Box 462, RFD 1
Augusta, Maine 04330
November 23, 1990

REF: Review of Draft Work Plan, Chempro Pier 91,
September 4, 1990

UPPER SAND AQUIFER CONTOUR MAP
MARCH 1, 1989

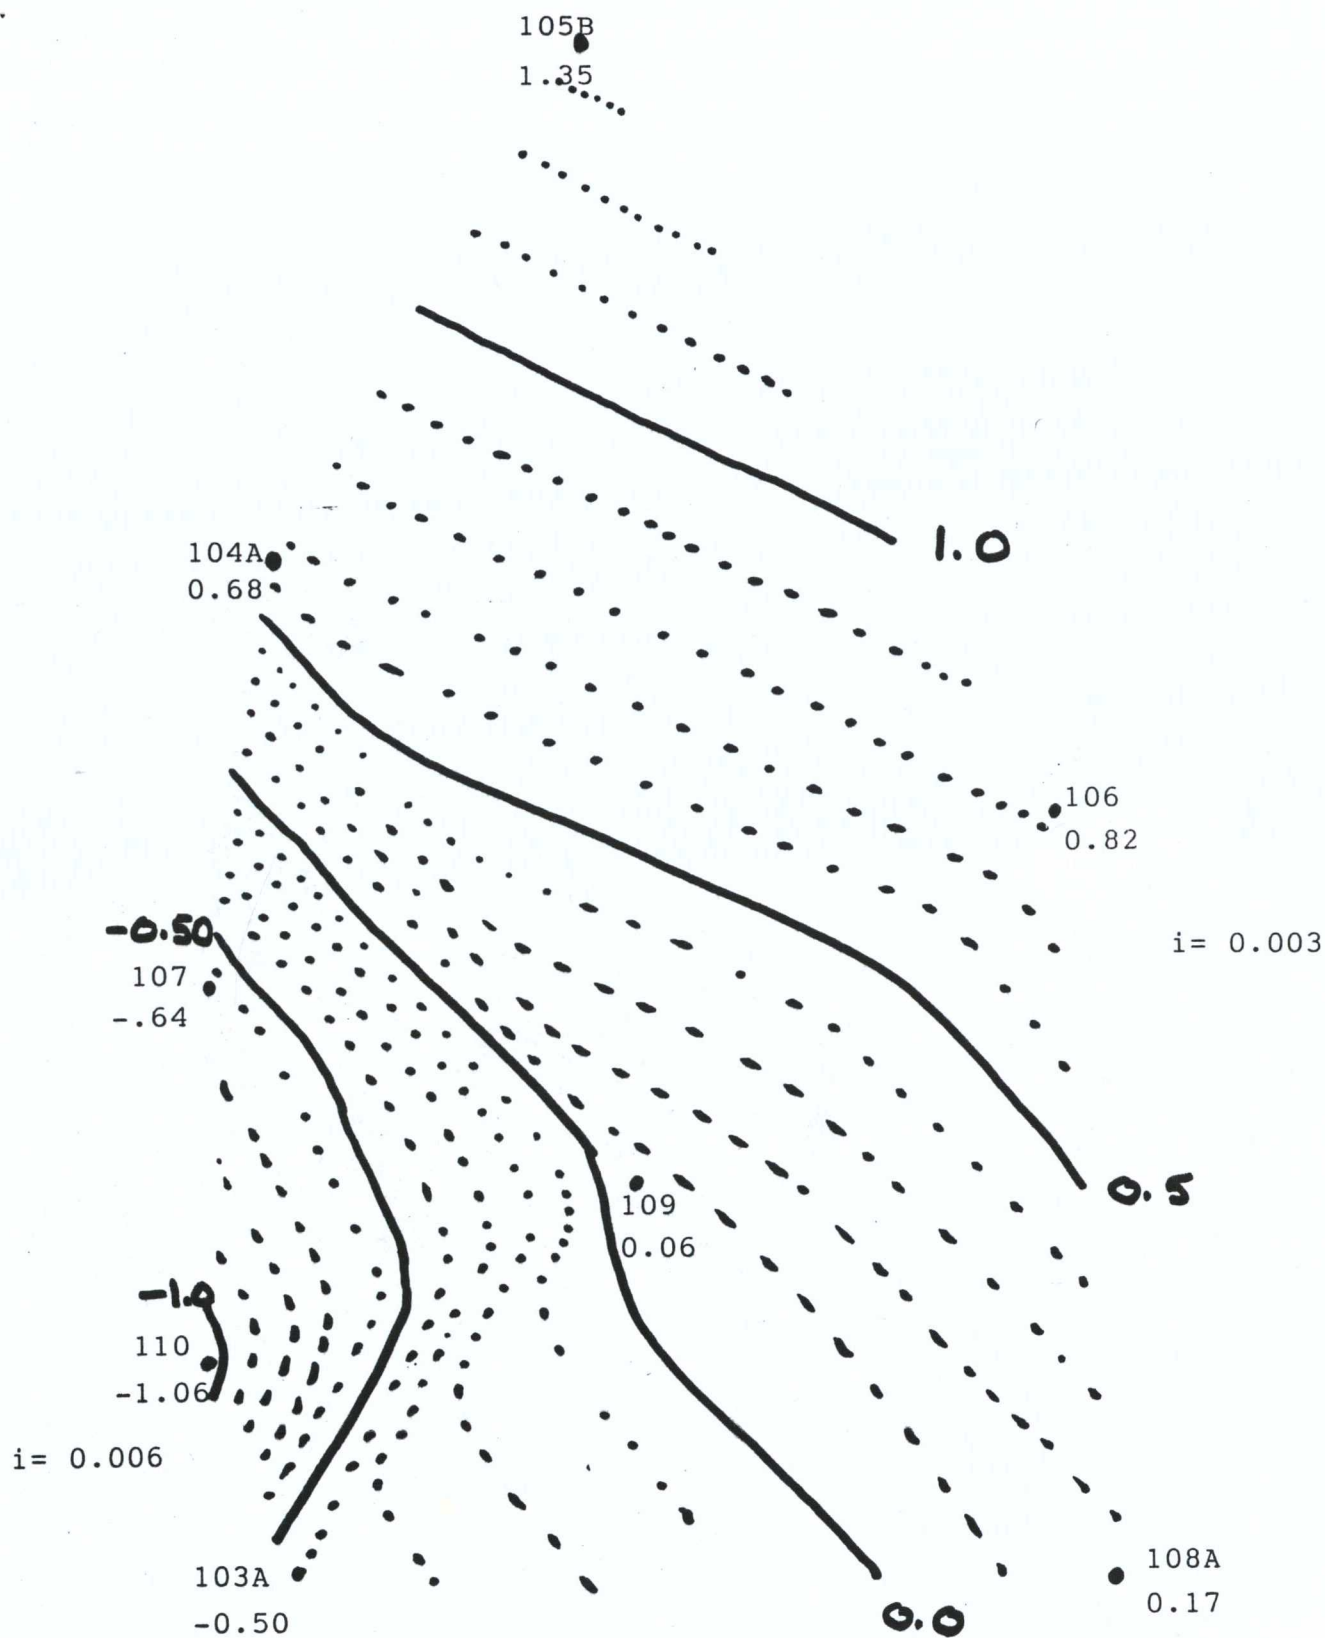
Attached figure 2 is a contour map of the March 1, 1989 head data for the shallow aquifer. There is a doubling of the gradient between wells 106 and 109 and wells 109 and 107 or 110. This is in accord with what should be expected if the thickness of the aquifer is decreased by half. To move the same volume of ground water requires the doubling of the ground water velocity ($V=Ki/n$) and $Q=KiA$). Since Q , K , and n are constants, as the cross sectional area becomes smaller, only i can increase. negative head? -0.5
